<b>Delegated Report</b>		<b>Analysis sheet</b>		<b>Expiry Date:</b>	28/03/2017
		N/A		<b>Consultation Expiry Date:</b>	30/03/2017
<b>Officer</b>			<b>Application Number(s)</b>		
David Peres Da Costa			2017/0579/P		
<b>Application Address</b>			<b>Drawing Numbers</b>		
26 Netherhall Gardens London NW3 5TL			See decision notice		
<b>PO 3/4</b>	<b>Area Team Signature</b>	<b>C&amp;UD</b>	<b>Authorised Officer Signature</b>		
<b>Proposal(s)</b>					
Erection of a four storey (plus basement and sub-basement) detached property to provide 5 flats (4 x 2 bedroom and 1 x 3 bedroom), including front and rear roof terraces, hard and soft landscaping, boundary treatment and 3 car parking spaces, following demolition of the existing building (Class C3).					
<b>Recommendation(s):</b>		Refuse planning permission			
<b>Application Type:</b>		Full planning permission

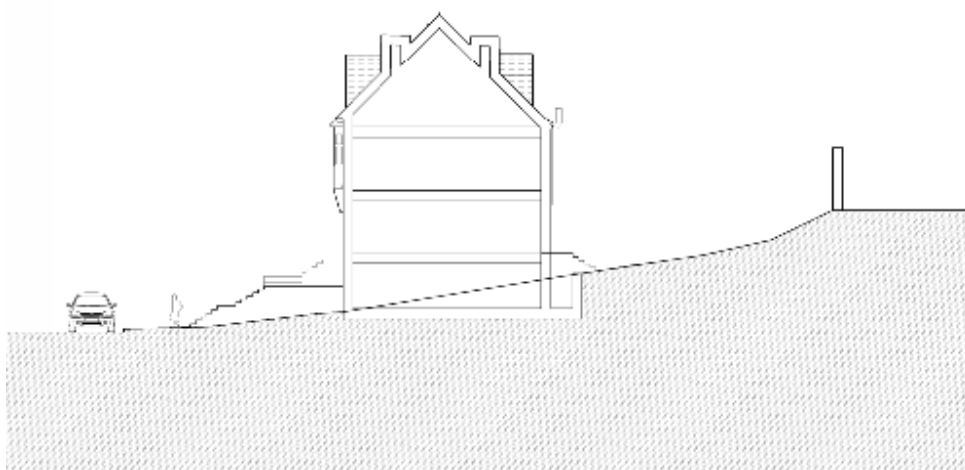
- 1.32. The proposed ground floor level would involve excavating a significant part of the existing garden right up to the boundary with 24A Netherhall Gardens (to the south) and 47 Maresfield Gardens (to the east). This is illustrated in the existing section AA and proposed section AA below. While it is unclear exactly where existing section AA is drawn through the site (as there is no accompanying plan to illustrate this), comparison of the existing section with proposed section AA is nevertheless informative.

- 1.33. The existing rear garden has an area of approximately 333sqm. Approximately 175sqm of the existing garden would be excavated to create the ground floor of the proposed development including a garden for Duplex Apartment 2. Due to the slope of the land, the garden created would be substantially below the existing ground level. The rear garden at ground floor level appears to require excavation of approximately 6.89m depth of soil. The ground floor and excavation of the private garden for Duplex Apartment 2 does not comply with policy A5. In particular it is contrary to policy A5h, A5k, Akl and A5m. Camden Planning Guidance (November 2017) states “the lowering of the natural ground level to the rear of the property should be minimised as much as is practicable” (paragraph 2.22).

- 1.35. The ground floor excavation would:
  - exceed 50% of the existing garden (A5h);

- extend into or underneath the garden further than 50% of the depth of the garden (A5k);
- would not be set back from neighbouring property boundaries where it extends beyond the footprint of the host building (A5l); and
- not avoid the loss of garden space of townscape or amenity value

- 1.37. It is therefore considered that the ground floor excavation would not be subordinate to the host building and would harm neighbouring amenity and the established character of the surrounding area contrary to Policy A5.
